20 May 2025

Re: Daylight and Sunlight – HGY/2024/0921: Erection of one additional storey at roof level to existing building to provide two self contained apartments, plant and associated works, Harcourt House, 16-17 Haringey Park, Hornsey, London, N8 9JB

***Image 4: Plan showing additional properties potentially relevant for consideration***

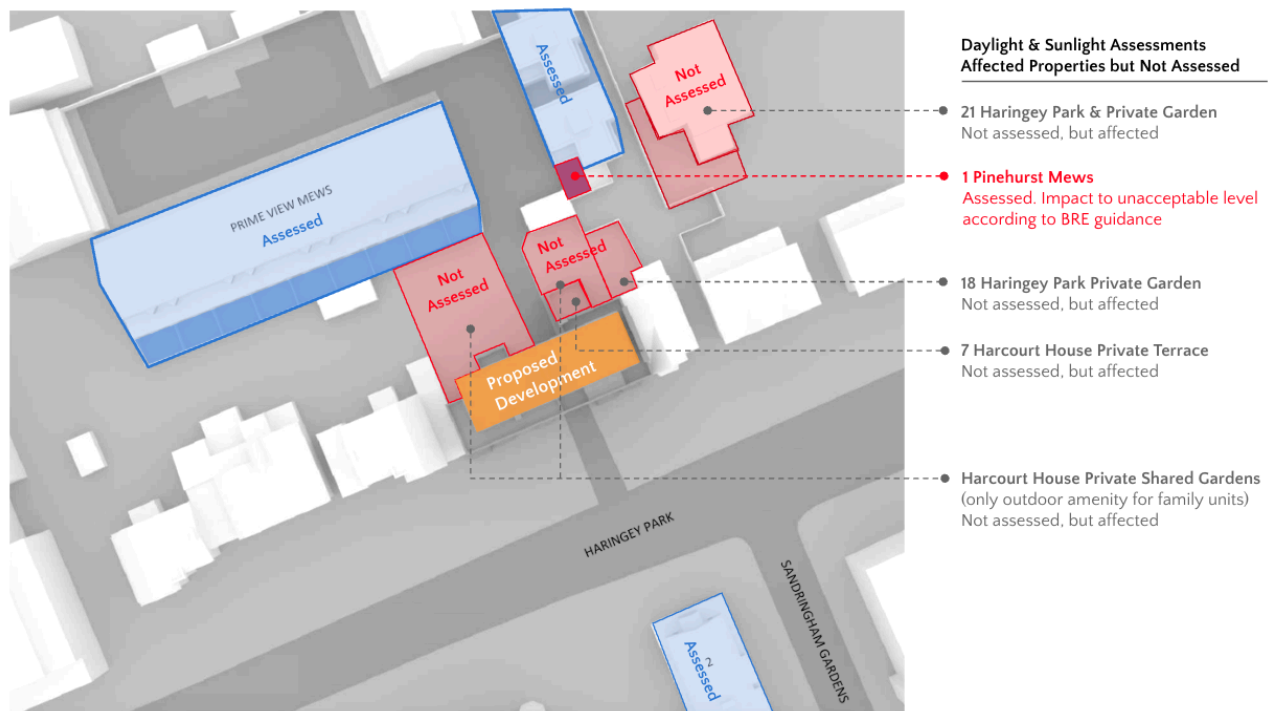
In addition to the omission of the assessment of the communal gardens the extent / scope of the daylight and sunlight assessments may be inadequate as they lack assessments for several properties and gardens that are in closer proximity to the proposals than the Pinehurst Mews gardens identified as impacted beyond the BRE targets. A number of objections and remarks have been raised to the council from the residents of those properties. These include:

- Private outdoor space for 7 Harcourt House
- Private garden for 18 Haringey Park
- Private garden and the property of 21 Haringey Park

The applicant's assessments of 16<sup>th</sup> April have identified a level of sunlight loss beyond the BRE targets to the private garden of 1 Pinehurst Mews. As such the applicant should extend their assessment to cover the properties identified above given their closer proximity to the development.

An extended and more detailed assessment of these effects is required to provide appropriate information on which to determine the application and confirm whether the proposed development impact is within acceptable standards outlined in the BRE guidance and policies above.

***Image 7 : Proposed modelling extracted from CHP report 17<sup>th</sup> September 2024 (p27)***

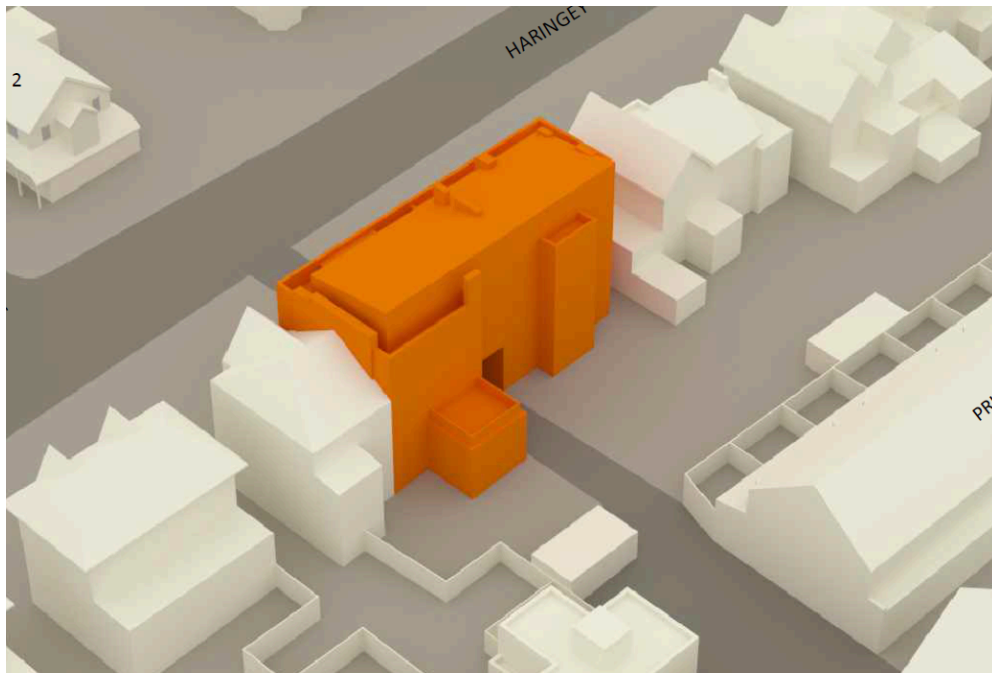
The above extract shows the proposal as a flat-roof extension to the existing Harcourt House building. This does not however reflect the proposed planning drawings which indicate a complex pitched roof extension with multiple ridges as per the section and 3D model below:

Whilst it is not clear whether the pitched roof proposal would lead to a greater impact when compared to the analysis presented in the daylight / sunlight report it is clear that the submitted technical work appears to be based on an incorrect interpretation of the extension proposals. The daylight and sunlight assessments therefore appear to be unreliable and this should be addressed prior to any decision in respect of the proposals.
